Title: Advisory Committee on Reactor Safeguards
Thermal Hydraulic Phenomena Subcommittee

Date: Thursday, August 23, 2001

11 The purpose of today's session is to
12 review the resolution of issues associated with the
13 Electric Power Research Institute Report TR-113594,
14 "Resolution of Generic Letter 96-06 Waterhammer
15 Issues". The Subcommittee will gather information,
16 analyze relevant issues and facts, and formulate
17 proposed positions and actions, as appropriate for
18 deliberation by the full committee.

hA Sensitivity for RBM

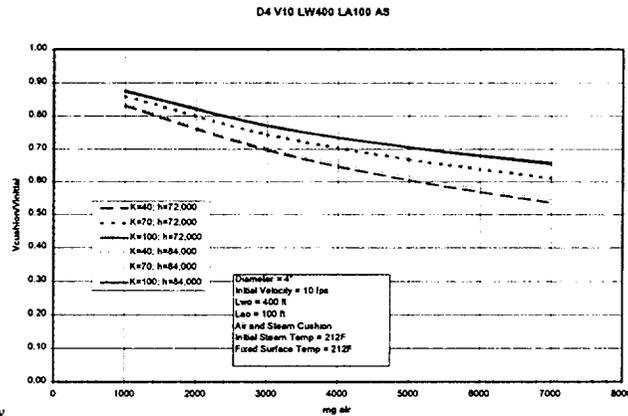
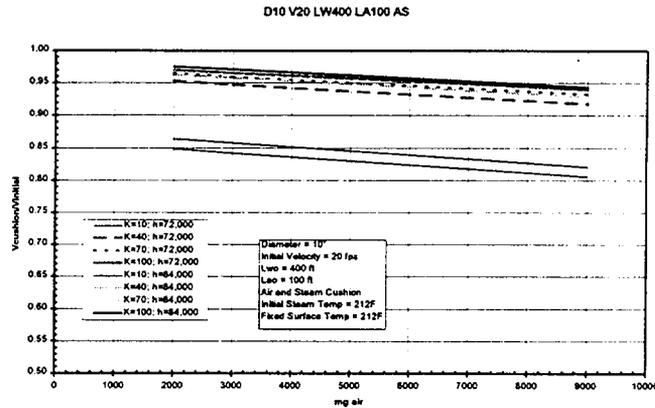
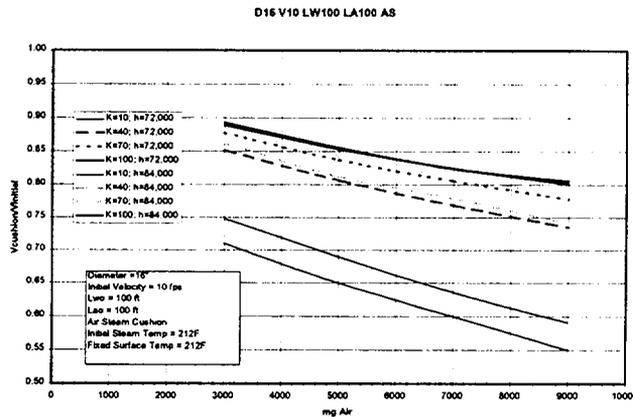
10 I think you have to go over the tests and
11 how they're run and what the results mean but I would
12 certainly try to focus and the "hA" argument was, in
13 my mind, a little shaky. I think you did go a long
14 way in convincing me on the conservatism in the air
15 release part. But I'm still not convinced on the "hA"
16 part. I'm not sure it matters what much but I would -
17 - I don't know how time you have but I would pursue
18 this jet argument and the question of how much
19 entrainment you actually get because I think this is
20 an entrainment heat transfer question.

- **ACRS T/H SUBCOMMITTEE:**
 - + LIMITATIONS OF AIR RELEASE FRACTION TEST APPARATUS
 - + DETERMINATION OF “h” FOR CONDENSING HEAT TRANSFER
 - + SENSITIVITY OF “SCALING-UP” TEST DATA TO PLANT DESIGN

- For plant application, the Rigid Body Model (RBM) was used to develop a series of curves showing the effects of void compression for various conditions.
- To assess the effect of variation in the hA on the RBM predictions waterhammer parameters, h was varied from 72,000 BTU/hr.ft².°F (h_{rec}) to 84,000 BTU/hr.ft².°F (25% above the largest h_{test}) in the Rigid Body Model equations.
- RBM curves were prepared for air and steam cushioning.

For a 4" diameter pipe, the cushioned velocity calculated using $h = 84,000$ BTU/hr.ft².°F increases by approximately 1% of the initial velocity for the low K case (low pipe resistance model). The change is less for the other cases.

For a 10" pipe, the cushioned velocity calculated using h equal to 84,000 BTU/hr.ft².°F increases by approximately 2% of the initial velocity for the low K case (low pipe resistance model). The change is less for the other cases.

For a 16" pipe, the cushioned velocity calculated using h equal to 84,000 BTU/hr.ft².°F increases by approximately 3 to 4% of the initial velocity for the low K case (low pipe resistance model). The change is less for the other cases.
